September 14, 2016 - DRAFT  
Carey & Co. / a TreanorHL Company

Project Analysis for Adherence to  
The Secretary of the Interior's Standards for the Treatment of Historic Properties

221 North Mathilda Avenue Sunnyvale, CA

fig. 3. Site Plan showing full site development. The historic house is at the upper right.

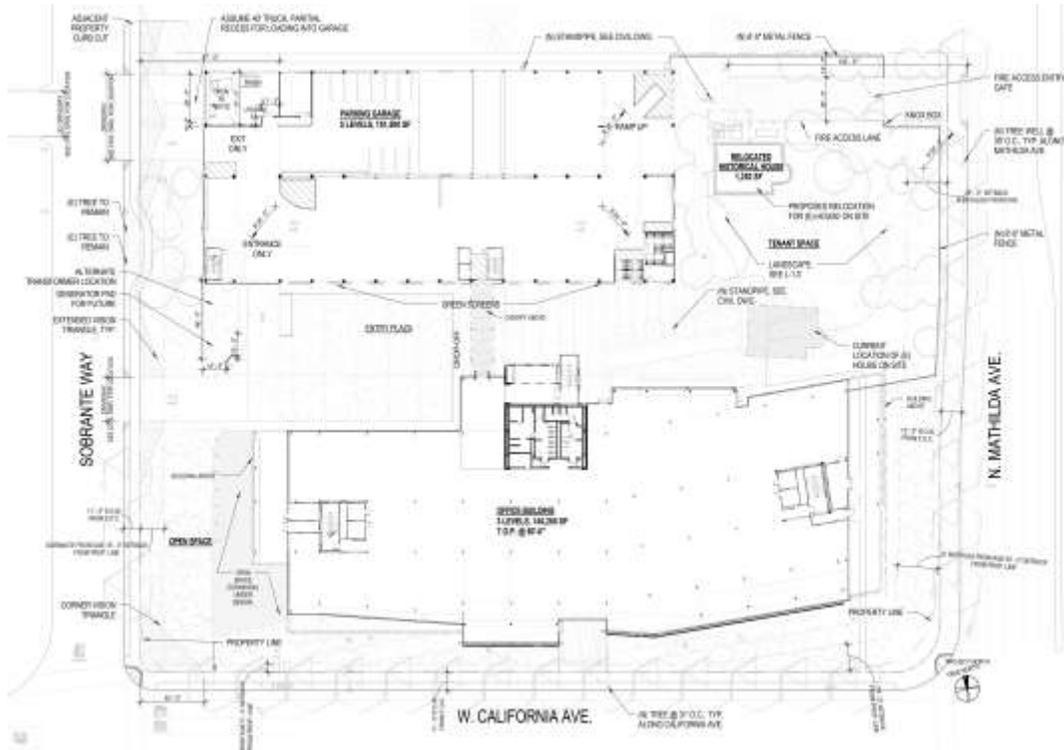
- Move the house to its new location and pour new foundations providing seismic resistance and code compliance. Repair understory framing as required. The new foundations will be designed so as not to impinge on the root systems of the trees which will remain on site.
- Remove the existing brick chimney. Construct a brick veneer chimney above the roof line at the original location to serve as a mechanical vent. The chimney will match the height and dimensions of the original.
- Abandon and demolish the existing, non-historic concrete porch, steps and iron railing. After the move, construct a wood porch and steps and install two Tuscan columns following the plan and photograph published in 1907.
- Abandon and demolish the existing, non-historic back entry steps and deck. After the move, construct a new accessible, A.DA - compliant back entry deck (figs. 3 & 4).

fig. 4. Site Plan detail showing the existing and proposed historic house locations

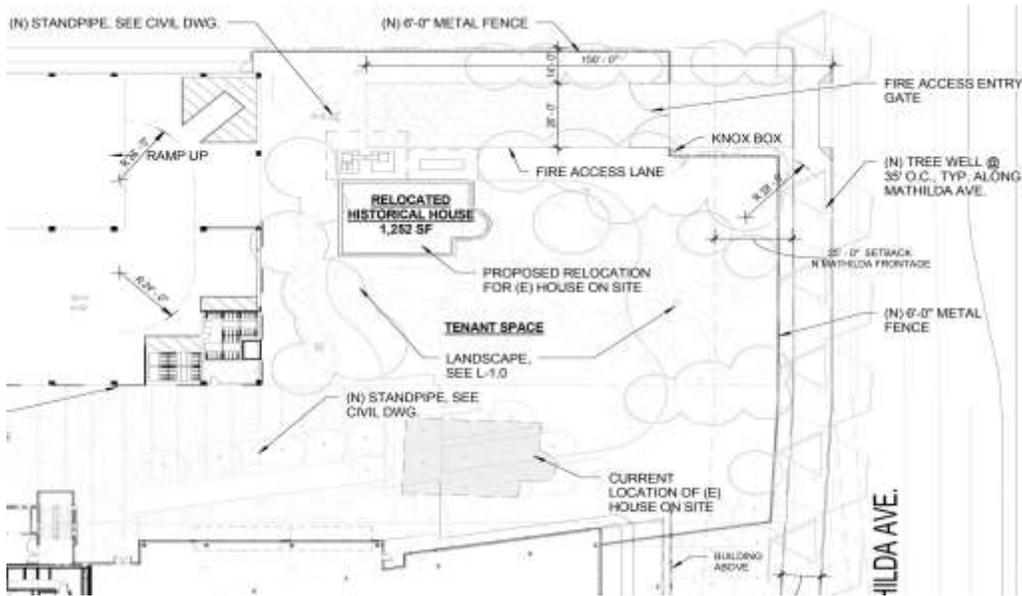
Relocation and Rehabilitation. The work includes the relocation of the house within the existing property to a location approximately 100 feet to the north, and slightly to the west. It will retain its original cardinal orientation, and will continue to face Mathilda Avenue. The details of the work are as follows:

fig. 5. Front or East Elevation facing North Mathilda Avenue showing restored porch

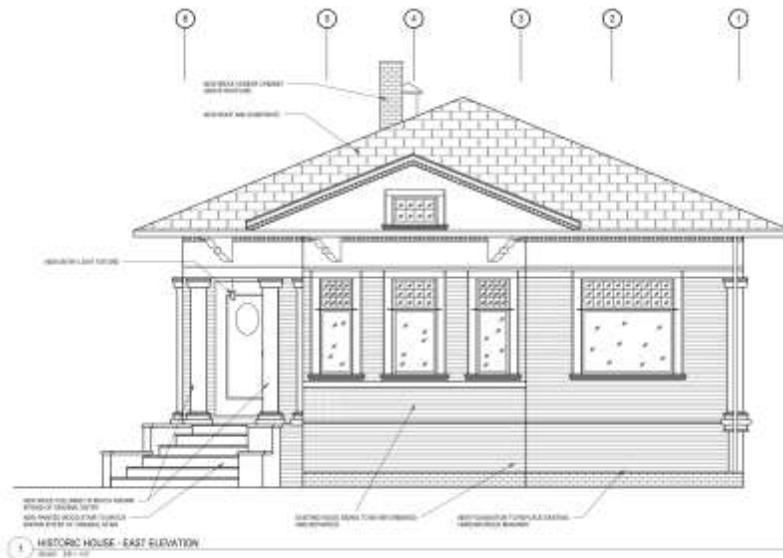
- Windows - Retain historic glazing. Remove windows for repair and installation of new glazing compound.. Reinstall windows and make all moving sash operable.
- Walls - The walls are generally in good condition. Where damaged or deteriorated the wood siding will be replaced in-kind with matching materials and profiles. A non-historic door on the north elevation will be removed and the opening patched with in-kind wood siding.
- Painting and Ornament - The house has many layers of paint that in particular obscure the details in the architectural ornaments and moldings. The original paint will be carefully removed with particular care given to ornamental elements to preserve the definition of their forms. The house will be primed, patched and repainted (figs. 5, 6, 7 and 8).

fig. 9. Plan showing interior alterations

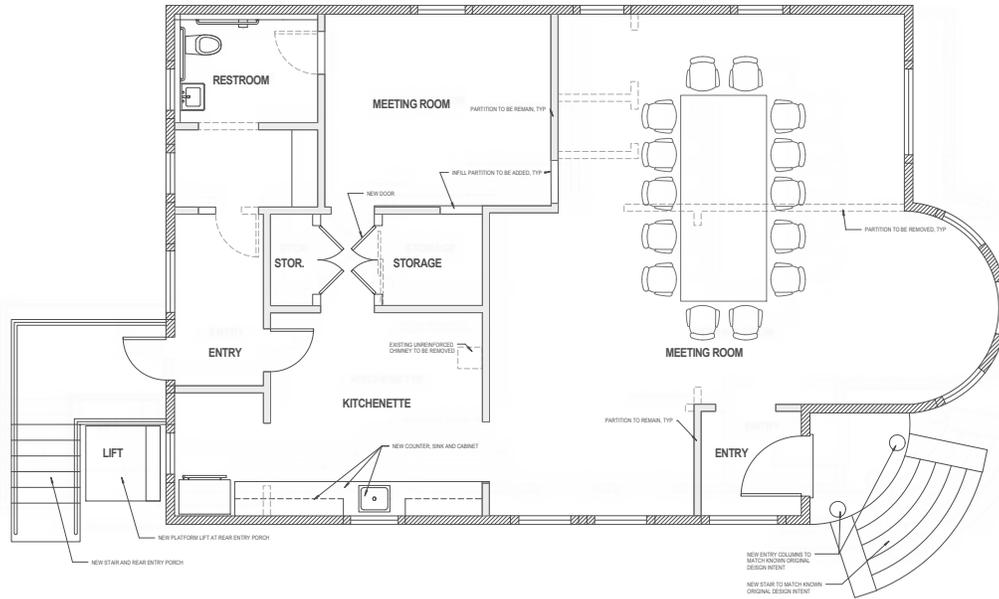
- The interior appears to have been altered mid-century with the additions of a bathroom and a toilet room as well as a shower. The wall containing pocket doors between the Parlor and Dining Room that appears on the floor plan published in 1907 is missing.
